CITY OF BEAVERTON  
TRANSPORTATION SYSTEM PLAN

Recommended Amendments to the September 1997 Draft TSP  
Accepted by Planning Commission and City Council (2198) to be included in the  
TSP Implementing Amendments

Attachment A - Recommended Changes

**Recommended Changes and Corrections to the  
Draft 1997 TSP  
(1198 – 10115198)**

# 1997 TSP – Figure 8-20 A

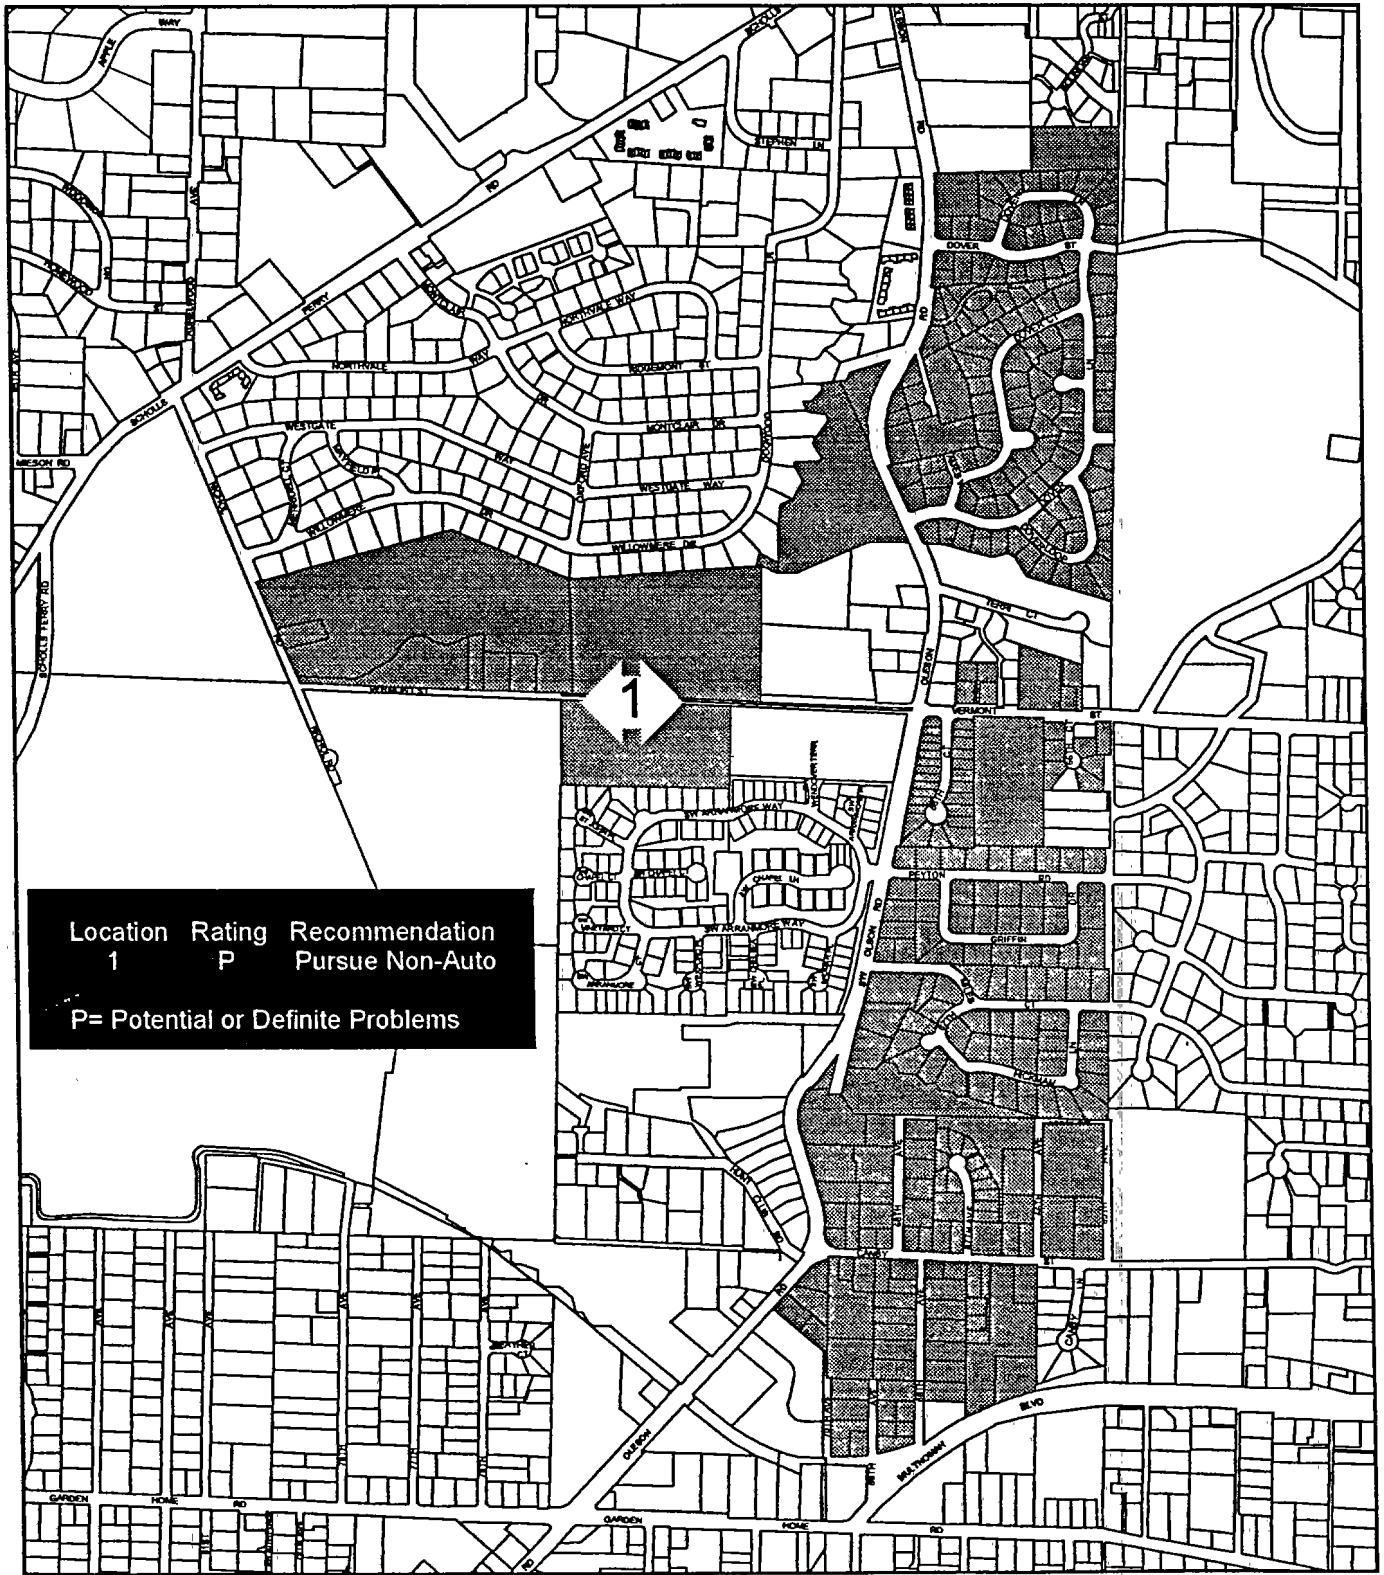
1. 1997 TSP addition due to City annexation: Add Local Connectivity Map to 1997 TSP as Figure 8-20A – Vermont Avenue; Rating: P; Recommendation: Pursue Non-Auto. (attached and included in CPA 98020 action)
